**UNITED STATES ENVIRONMENTAL PROTECTION AGENCY
REGION 8**

Re: Underground Injection Control (UIC) Program Aquifer Exemption Approval
Windy Hill Water Operations, LLC, Windy Hill #3-17D, Morgan County, Colorado

AQUIFER EXEMPTION RECORD OF DECISION

Figure 1. Stratigraphic Column from Windy Hill #3-17D, Windy Hill Water Operations, LLC

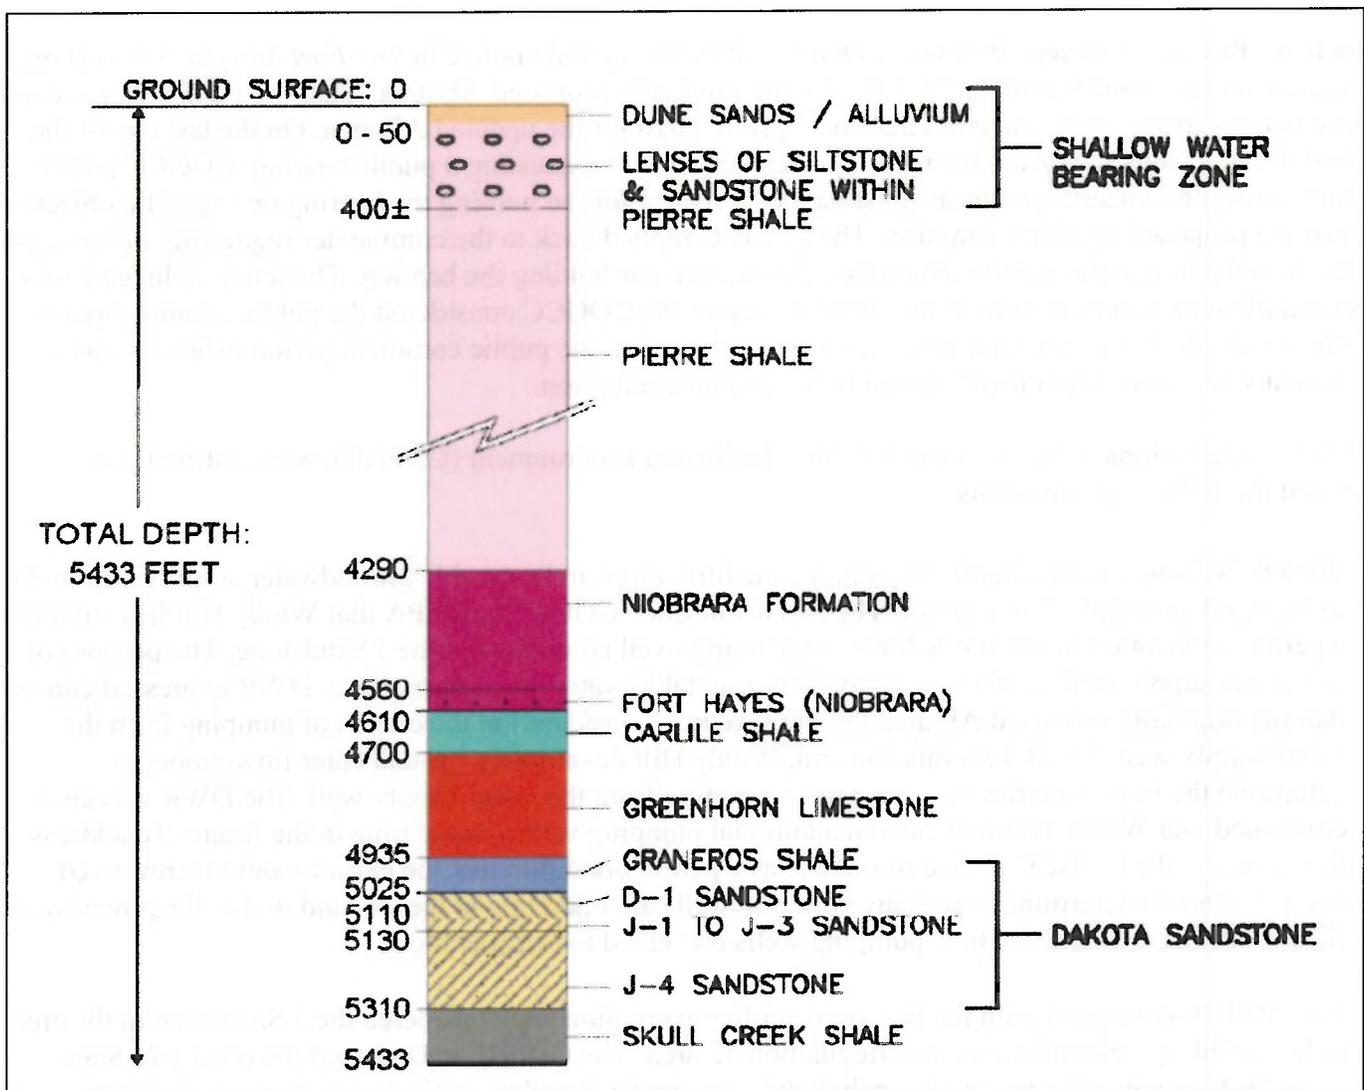
The confining zones are shown in stratigraphic column in Figure 1. The proposed exempted aquifer is the J Sandstone of the Dakota Group.

At the location of the Windy Hill #3-17D well, the top of the J Sandstones is encountered at a depth of 5,110 feet below ground surface (bgs) and the base of the J Sandstones (top of the Skull Creek Shale) is at 5,310 feet bgs according to geophysical well logs. Only the J-1, J-2, and J-4 Sandstones are present; the J-3 Sandstone is absent. The geophysical logs for Windy Hill #1-17D well indicate that the D-1 Sandstone and the D-2 Sandstone are actually shale in this location. The J-1 and J-2 Sandstone are intersected by the well at 5,110 to 5,130 feet bgs. The thickness of the J-4 Sandstone is approximately 180 feet, extending from 5,130 to 5,310 feet bgs. The Windy Hill #3-17D well is perforated from 5,130 to 5,300 feet bgs. However, there is no evidence to indicate that the J Sandstones are not one hydrologic unit. Therefore, the vertical extent of the exempted aquifer is 200 feet from 5,110 feet to 5,310 feet bgs.

Figure 2. Locations of water wells located near the Windy Hill #3-17D Well

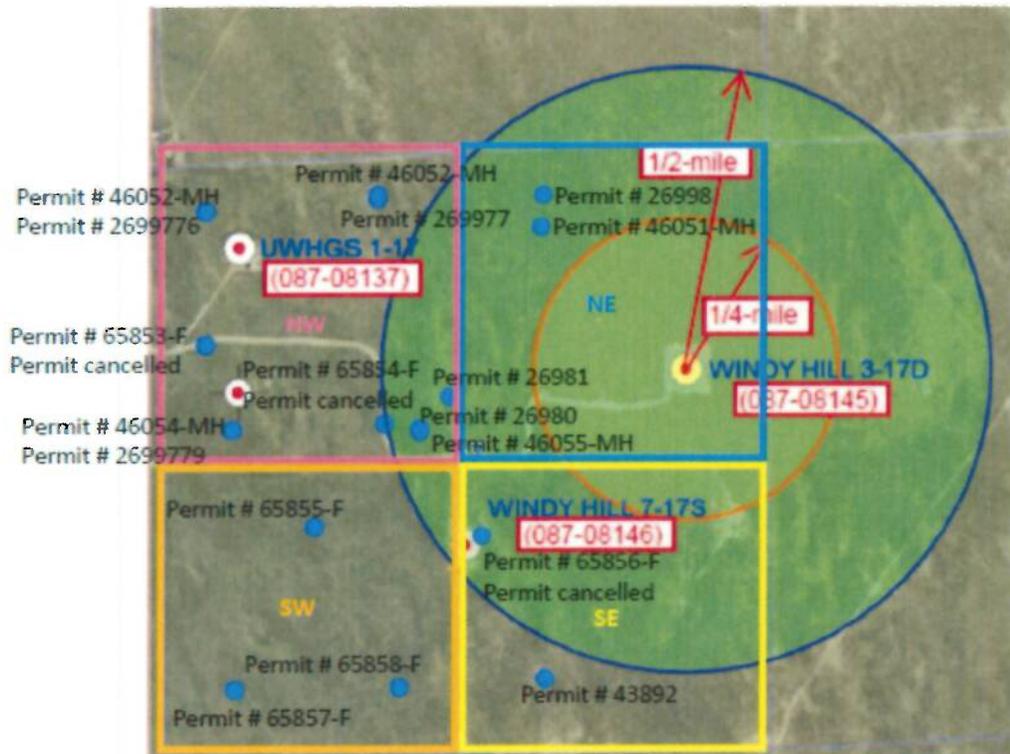
A search in the Colorado Division of Water Resources (DWR) online water well database indicated that permits have been issued for 18 private wells within ¼ mile of the updated AE boundary. Table 1 lists information about each of these wells. The well locations are shown on Figure 2. Reported well depths range from 60 to 88 feet. All wells listed in Table 1 are vertically isolated from the Dakota J Sandstone, the aquifer requested for exemption, by several thousand feet of low-permeability shale.
